**First Five-Year Review Report for the
Building 850/Pit 7 Complex Operable Unit at
Lawrence Livermore National Laboratory
Site 300**

April 2016

Environmental Restoration Department

Figure 3. Building 850 and Pit 7 Complex area site map showing monitor, extraction, and injection wells, springs, treatment facility and other remediation features.

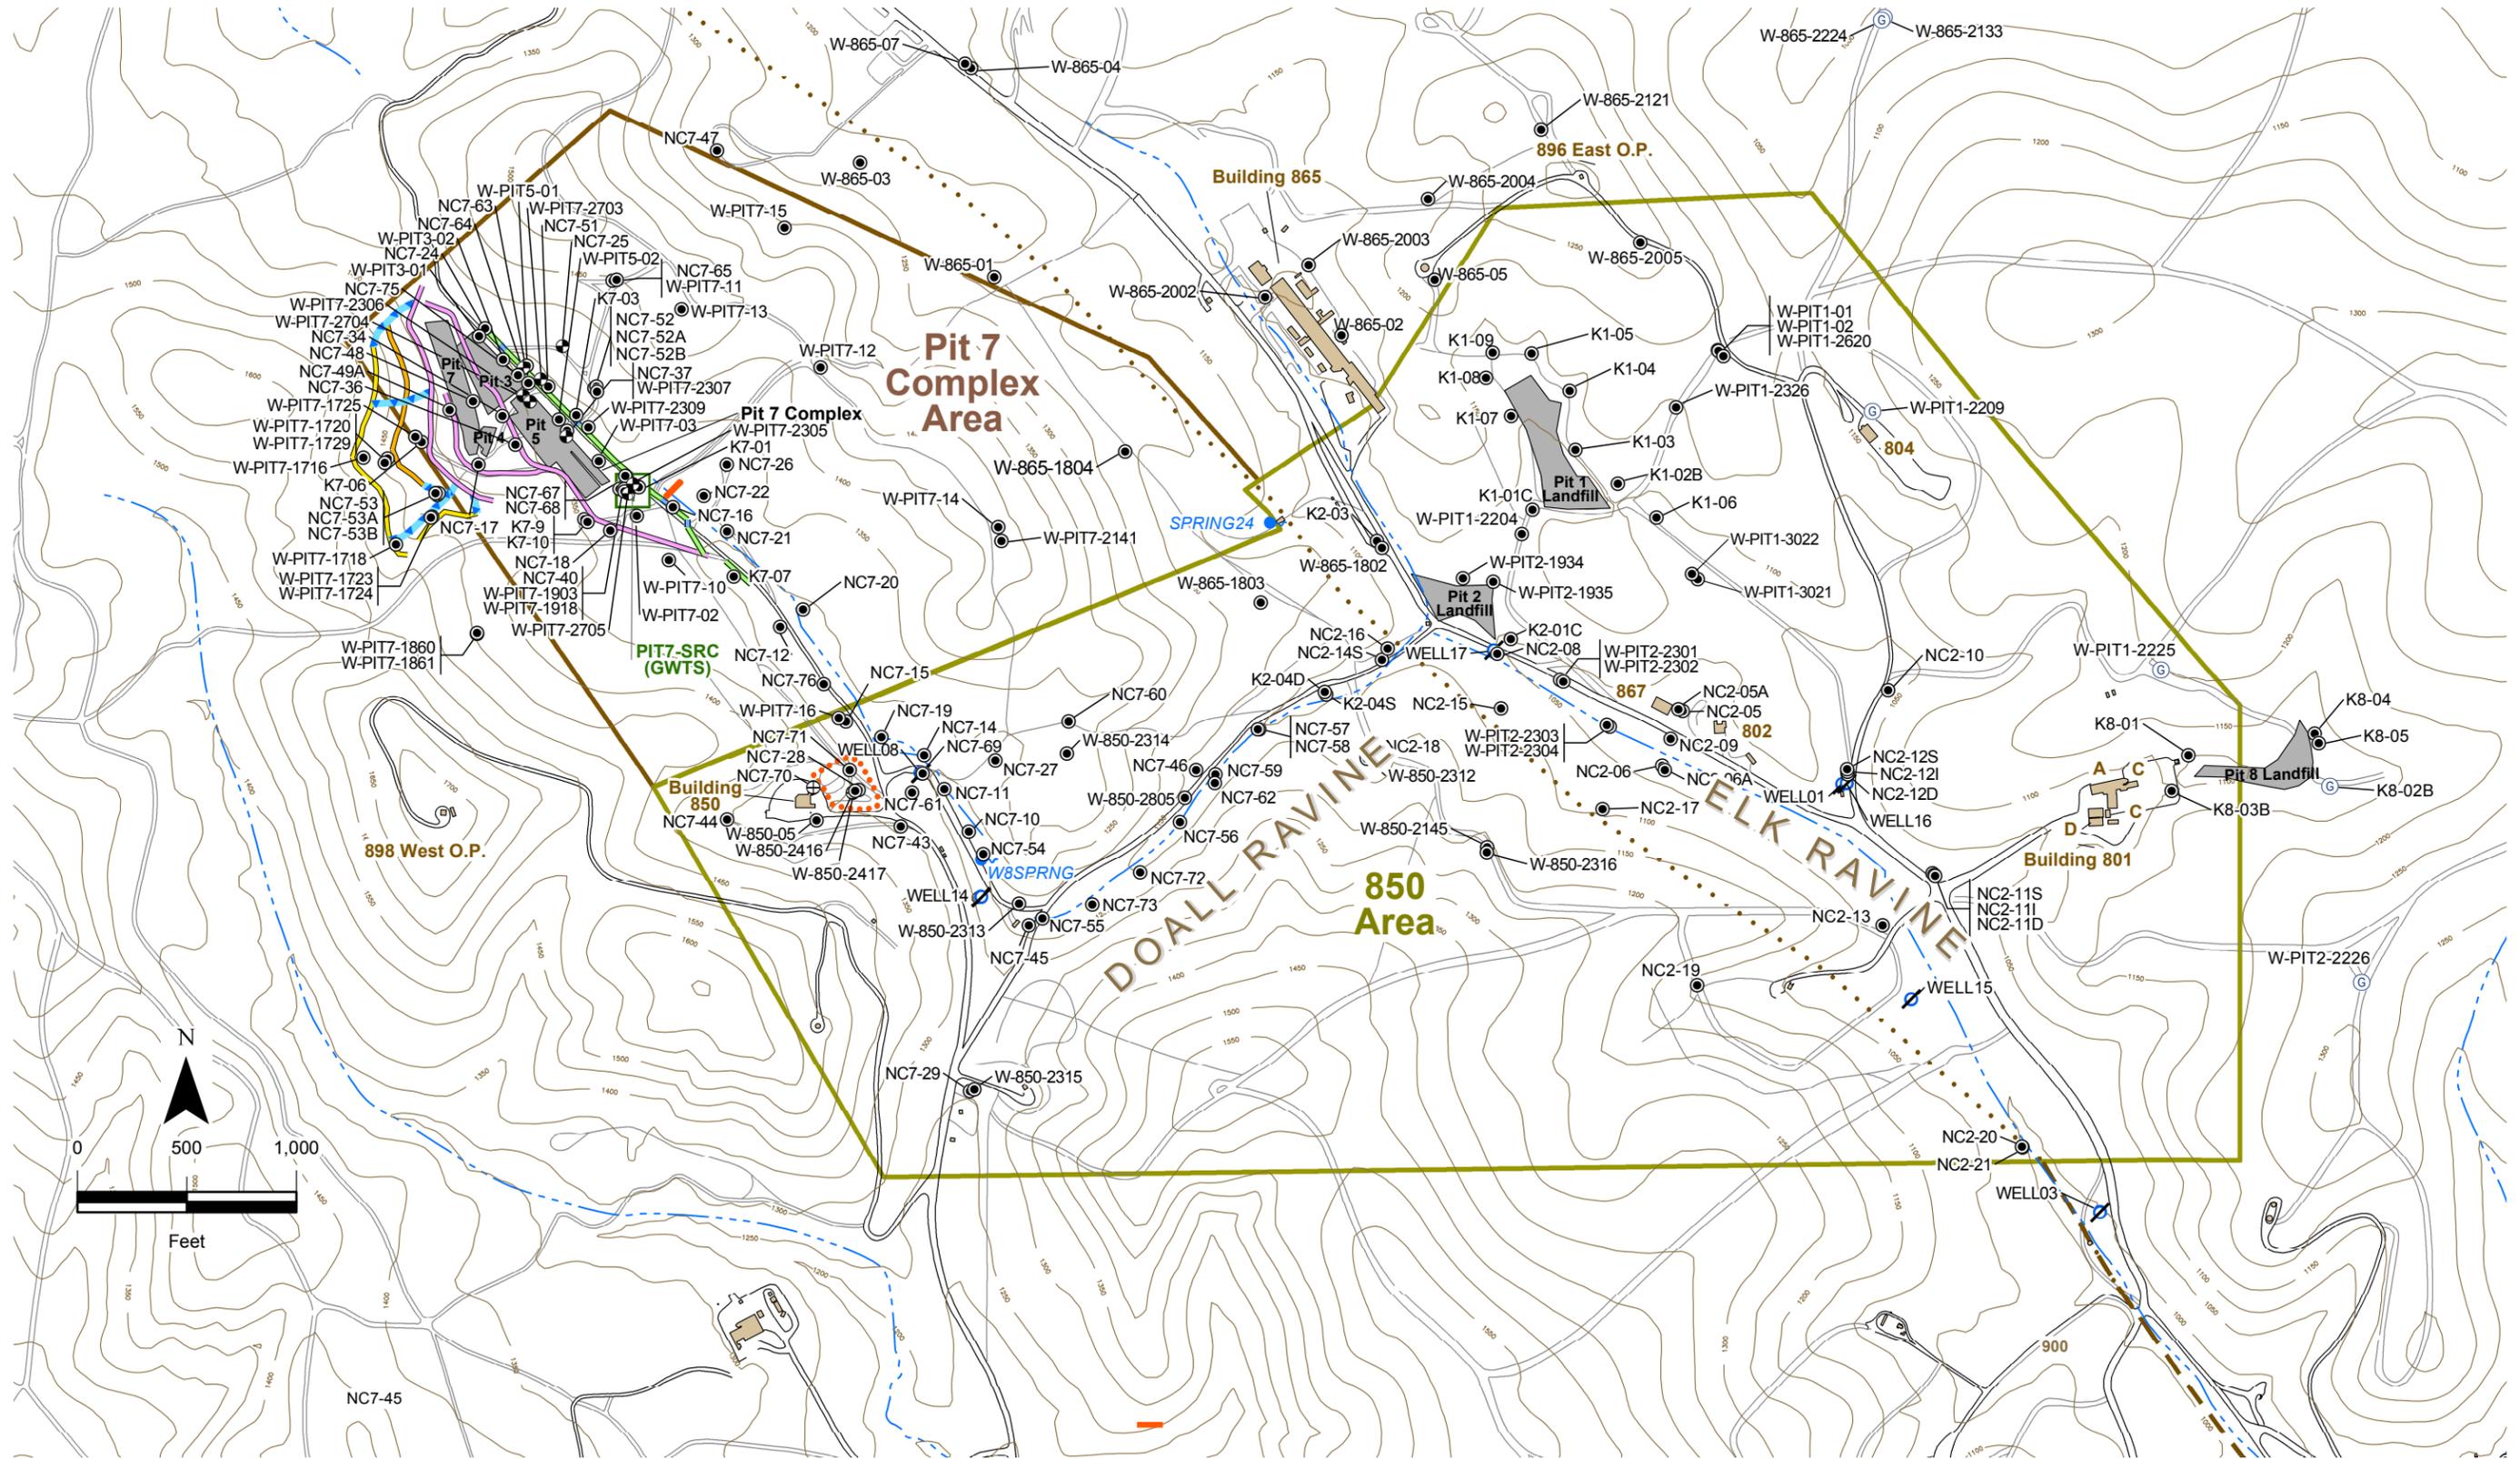
- 12. Section 3.1.1.2, Pit 7 Complex Site Description, Page 15:** The Pit 7 Landfill subsection indicates that the locations of Doall and Elk Ravines, the landfill, drainage diversion system, extraction and monitor wells, and the treatment system are presented on Figure 3. Please revise Figure 3 to identify the Doall and Elk ravines as noted in Section 3.1.1.2.

Response: Figure 3 has been revised to denote the locations of Doall and Elk Ravines.
